Docket No. 52-002

Subject: System 80+™ Supplement to RAI Responses

SYSTEM 80+
REACTOR COOLANT PUMP
SEAL DESIGN
&
PERFORMANCE

Figure 2 Flow Diagram for Hydrodynamic Shaft Seal System.
 Normal Operation - with CCW & SI

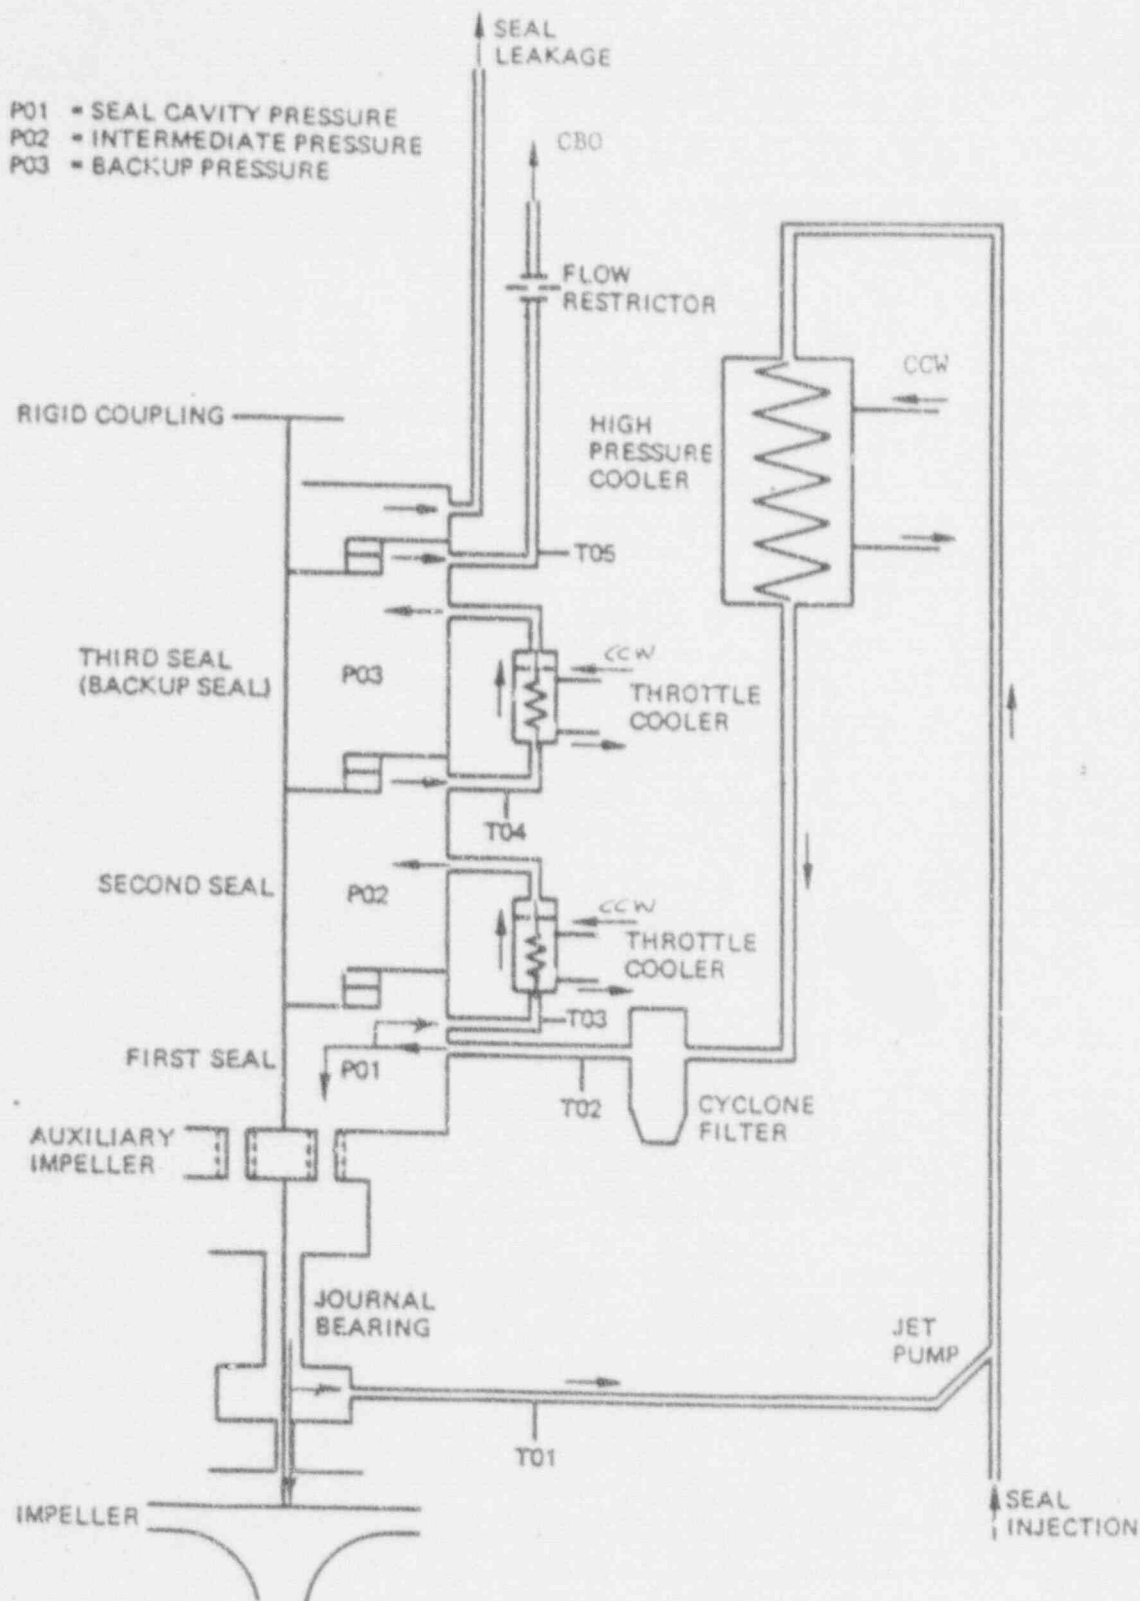
RCP SEAL INJECTION/CVCS DESIGN
(RAI 440.118)

SEAL COOLING

- o SEAL COOLING PROVIDED BY INDEPENDENT AND REDUNDANT COOLING SYSTEMS
 - SEAL INJECTION (SI) WATER (6.6 GPM EACH PUMP AT 120°F) INTRODUCED INTO SEAL COOLING CIRCUIT.
 - COMPONENT COOLING WATER (CCW) WHICH COOLS SEAL WATER BY HIGH PRESSURE SEAL COOLER (HPSC) AND THROTTLE SEAL COOLERS (TSC).

- o SEALS CAN OPERATE INDEFINITELY WITH:
 - LOSS OF SEAL INJECTION (SI) WATER WITH COMPONENT COOLING WATER AVAILABLE.
 - LOSS OF CCW WITH SI AVAILABLE.

Figure 3 Flow Diagram for Hydrodynamic Shaft Seal System.
 Operation without SI & with CCW

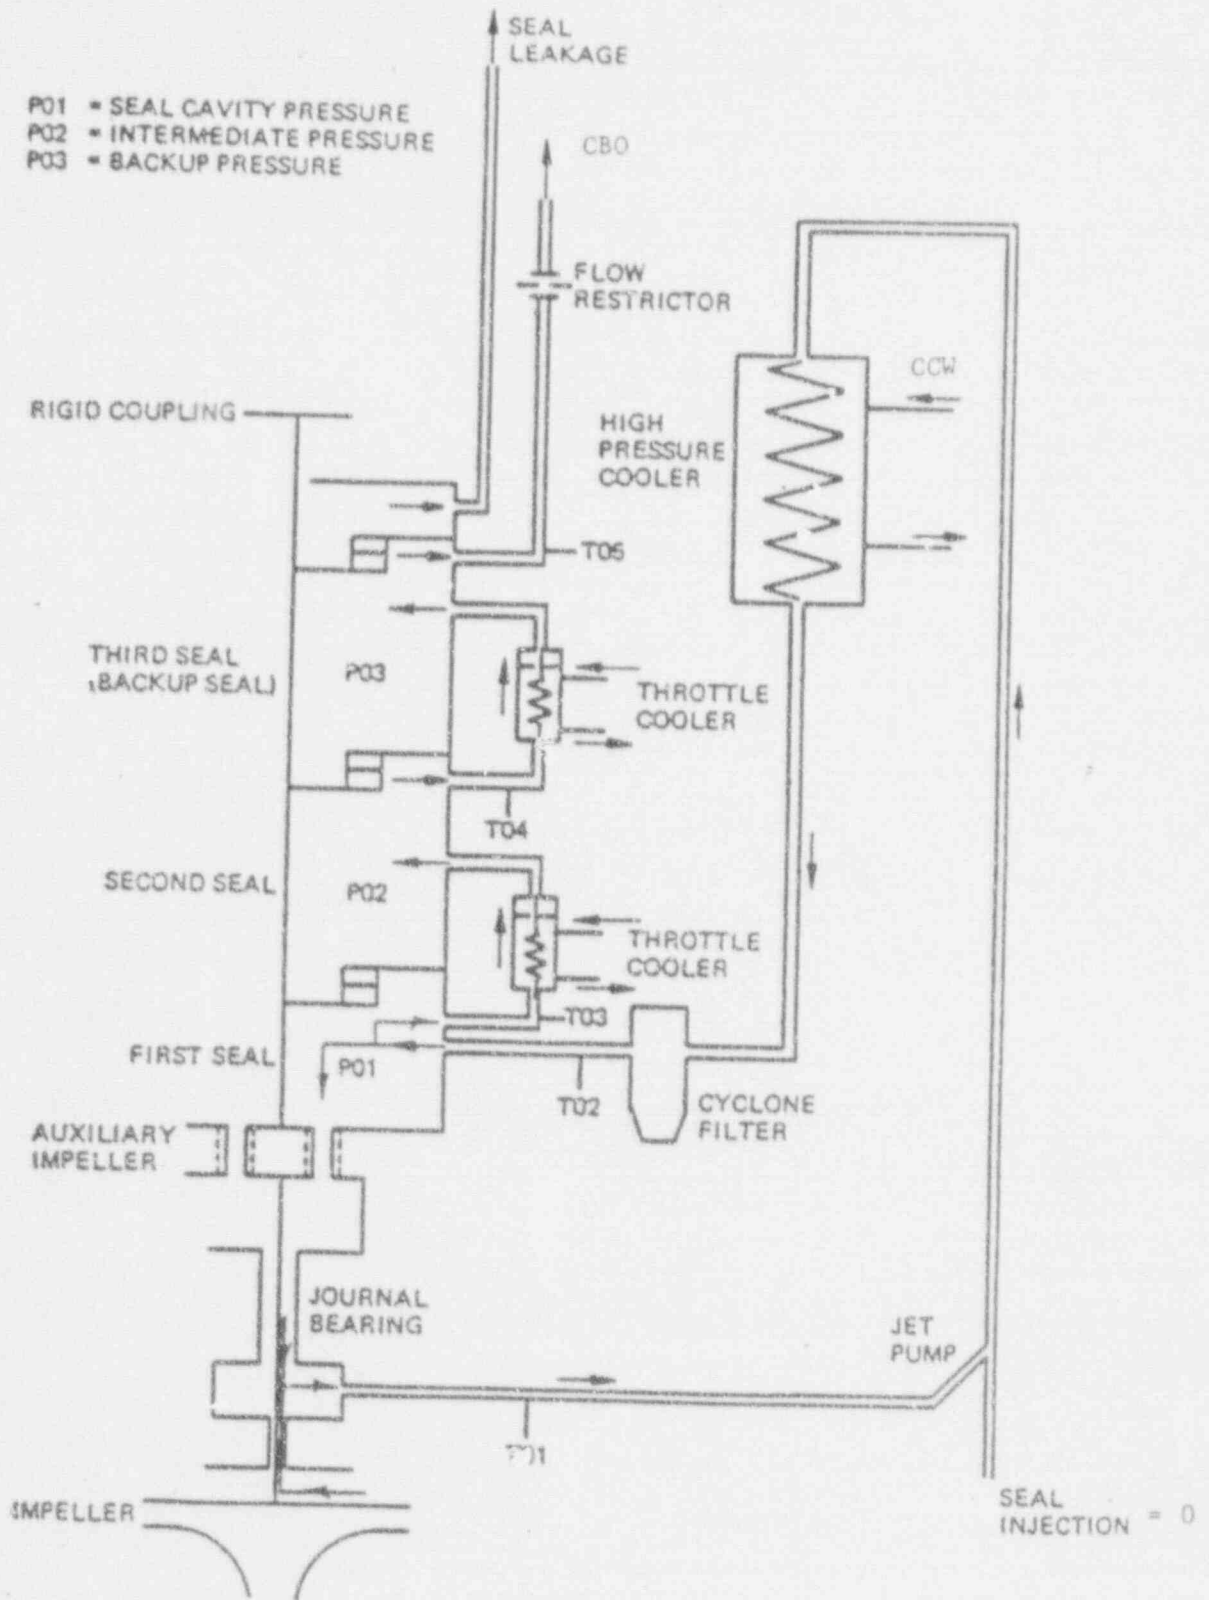
RCP SEAL INTEGRITY ISSUES (RAI 440.119)
